Docket Item # 11
BAR CASE # 2006-0245

BAR Meeting
November 15, 2006

ISSUE: Addition and alterations

LOCATION: 505 South Royal Street

Figure 1- Proposed rear elevation

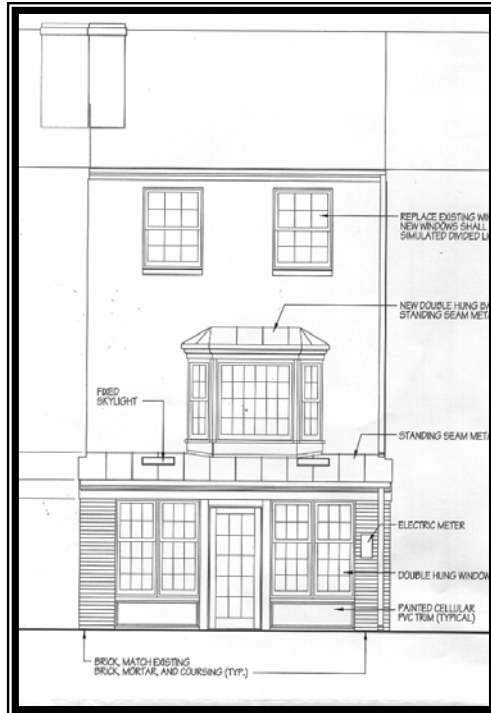
Staff believes the proposed alterations and additions are compatible with the mid-20th century building and the historic district. The addition is fairly modest in size and will only be minimally visible from the public right-of-way. The Board has previously approved significantly larger additions for buildings in this same development. While the *Design Guidelines* strongly recommend the use of authentic rather than synthetic materials, Staff believes the use of cellular PVC trim is acceptable in this application as it will not be accessible or readily visible to the public. Similarly, Staff has no objection to the proposed new bay window in the second story. The window type is appropriate to the vaguely Neo-Colonial style of the building. While it would be preferable that the window be centered, the bay will be in the location of the existing tripartite window which is off center. Lastly, Staff has no objection to the use of the Pozzi wood windows with aluminum simulated divided light muntins. While the *Design Guidelines* (Windows –Page 2) encourage the use of true-divided light windows, they do allow for simulated divided light windows in certain circumstances. In this case, the house is set back from Royal Street by more than 13' and is not accessible at the rear. Given these circumstances

Staff notes that the applicant proposes to retain all existing fences. As these stockade style fences do not comply with the *Design Guidelines* (Fences, Page 2), Staff strongly urges the applicant to consider replacing the fences as part of the renovation project. Staff may administratively approve wood flat board fences no higher than 6'. If during the course of the project it is determined that any of the fences requires replacement, that replacement fence must comply with the *Guidelines* and must be approved by Staff.

Staff recommends approval of the application with the following condition:

The statement below must appear in the General Notes of all site plans and on all site plan sheets that involve demolition or ground disturbance (including sheeting and shoring and grading) so that on-site contractors are aware of the requirement:

Call Alexandria Archaeology immediately (703-838-4399) if any buried structural remains (wall foundations, wells, privies, cisterns, etc.) or concentrations of artifacts are discovered during development. Work must cease in the area of the discovery until a City archaeologist comes to the site and records the finds.
